Title: TOP & POWER

Project: NU			
Size: A4	Reference: MB1136	Revision: C.3	
Date: 9/26/2014		Sheet: 1 of 4	life.augmented

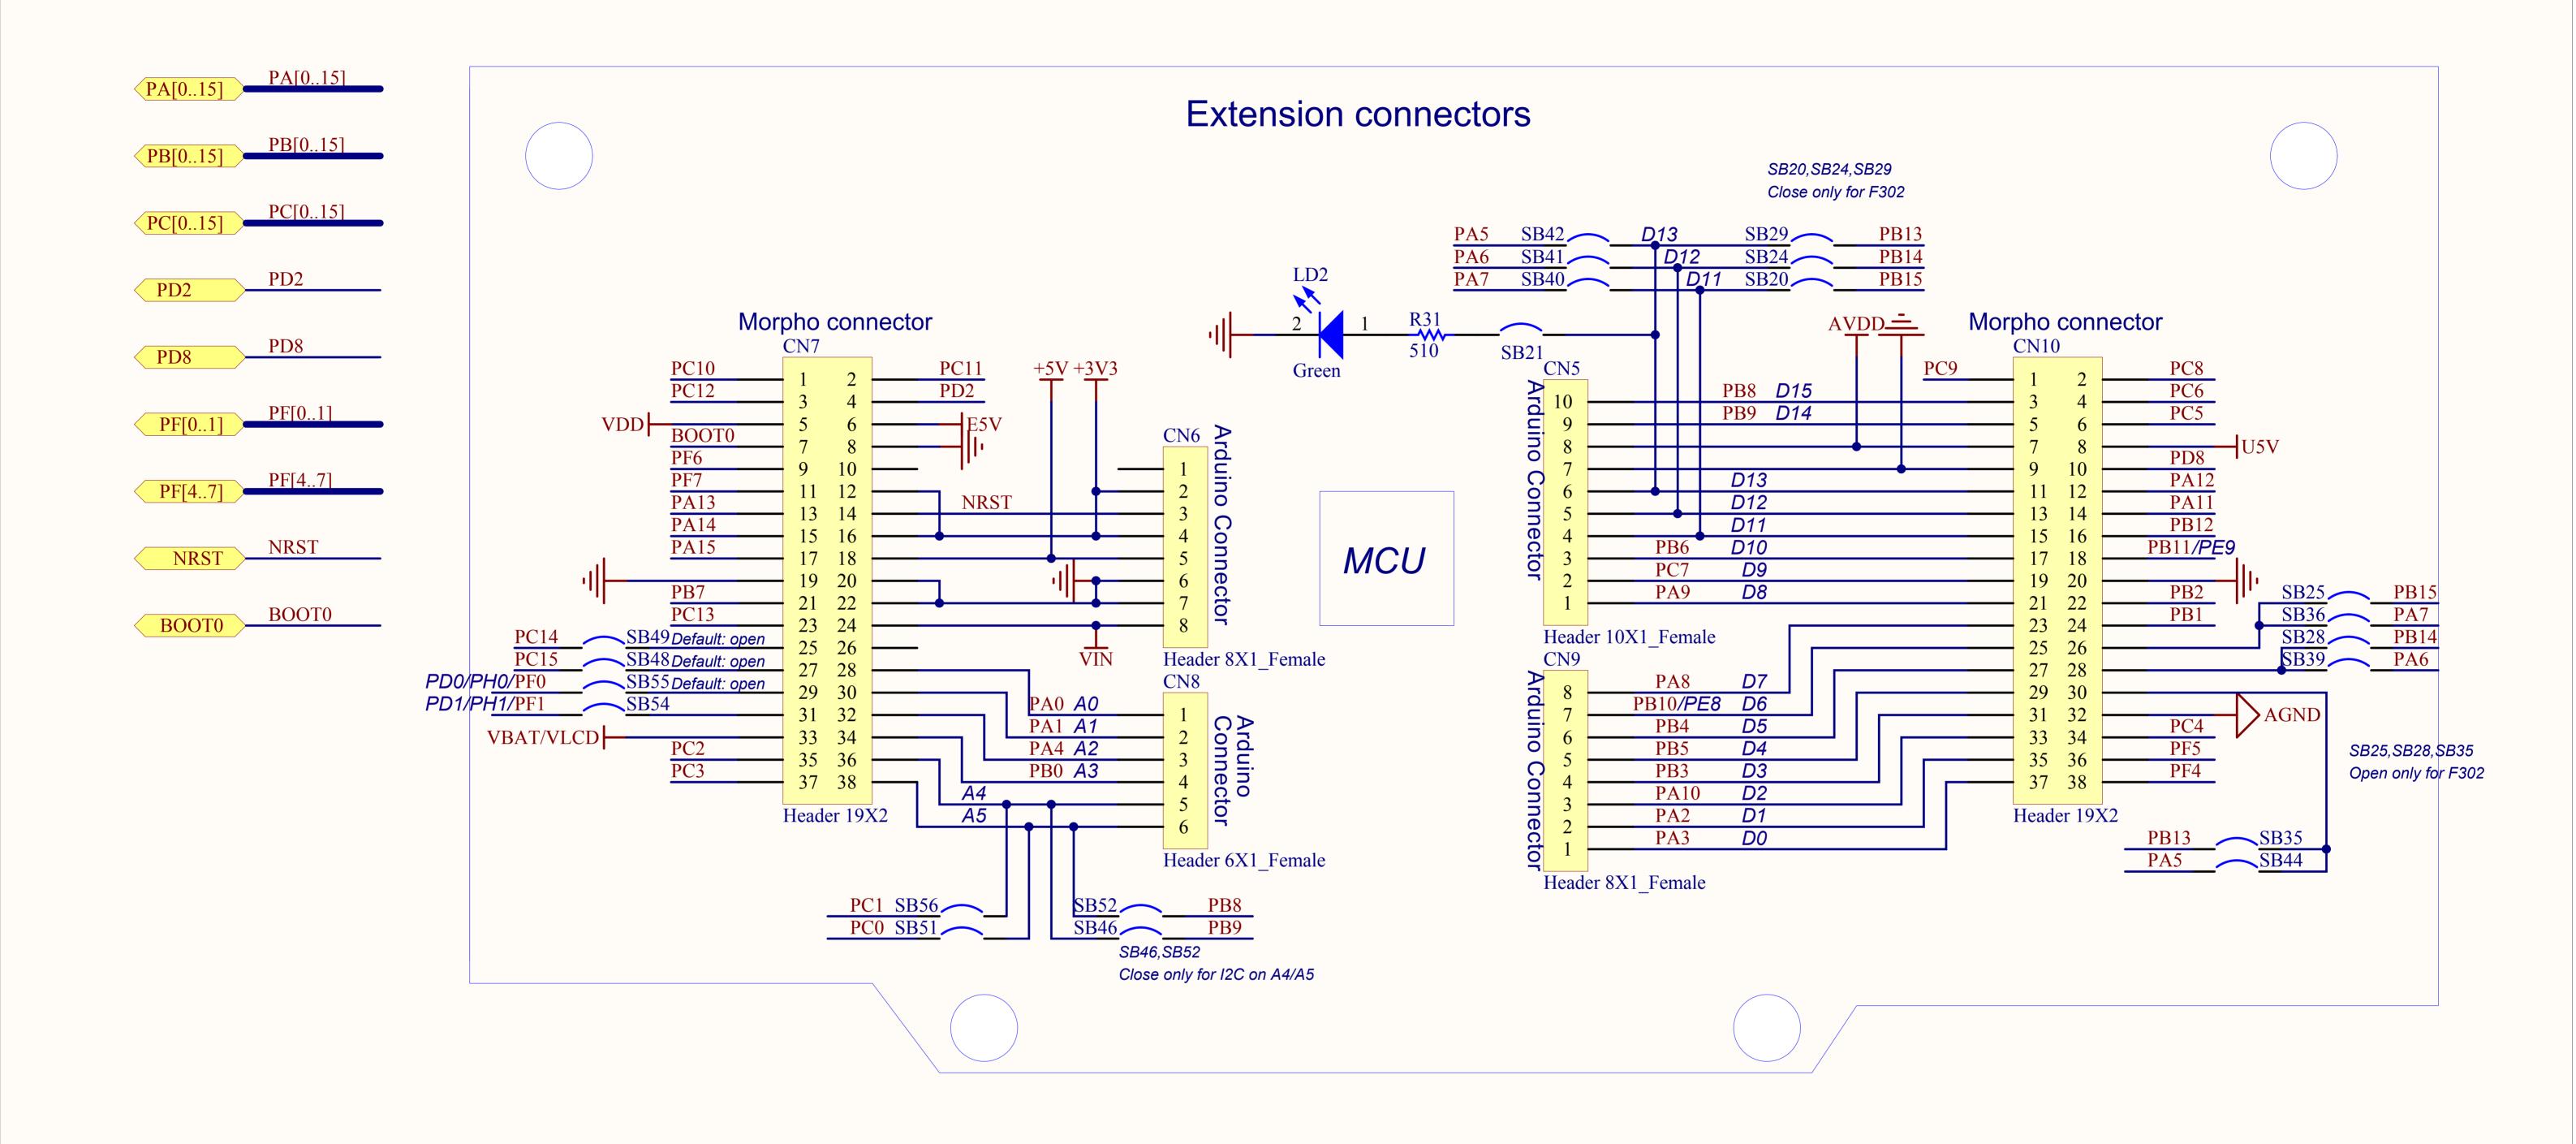
Note2: Remove [N/A] on R34, R36, C31, C32, X2 from C.1 to C.2

Note3: Add "default open" on SB48, SB49, SB55 from C.1 to C.2

Note4: Replace "default open" by "default closed" on SB16 & SB50 from C.1 to C.2

Note5: C31&C32 value changed from 10pF to 4.3pF to fit with new 32K crystal ABS25-32.768KHZ-6-T
